Licensee: Duke Energy

Facility: McGuire, Units 1 and 2, and Catawba, Units 1 and 2

SUBJECT: TELECOMMUNICATION WITH DUKE ENERGY CORPORATION TO DISCUSS
INFORMATION IN TABLE 3.2-4 OF THE LICENSE RENEWAL APPLICATION
TECHNICAL INFORMATION

Containment Spray Heat Exchangers

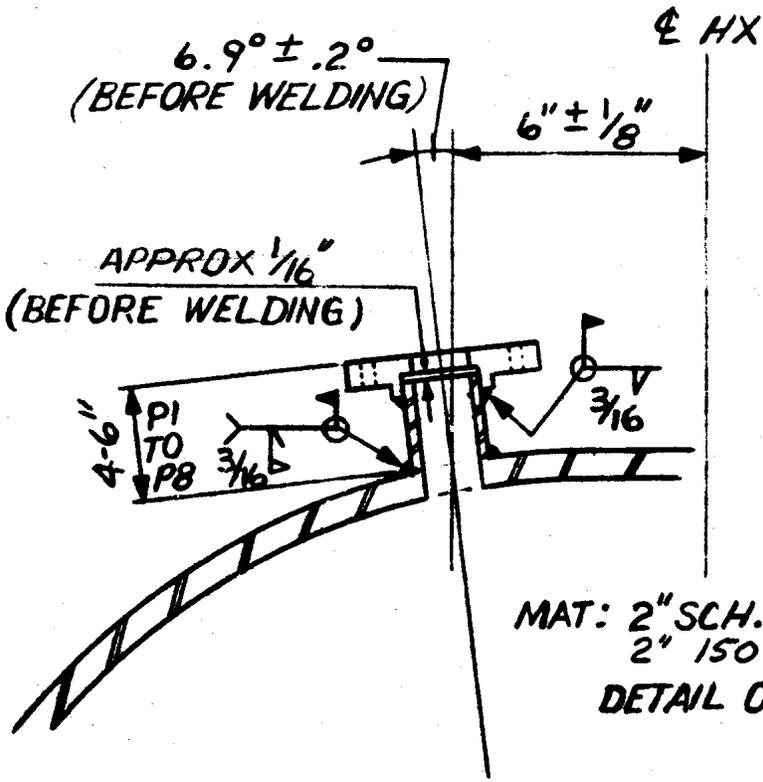
1. The applicant did not specify an external environment for containment spray heat exchanger stainless steel nozzles associated with 1NSHX0003, 1NSHX0004, and 2NSHX0003 on page 3.2-27 of the LRA. The staff asked if the stainless steel nozzles were exposed to an external environment that was not specified in Table 3.2-4.

The applicant indicated that the external environment is sheltered and that no aging effects would be applicable. The applicant provided a copy of a component drawing to the staff so that the external surface material of the nozzles could be verified. The drawing is presented in Attachment 2.
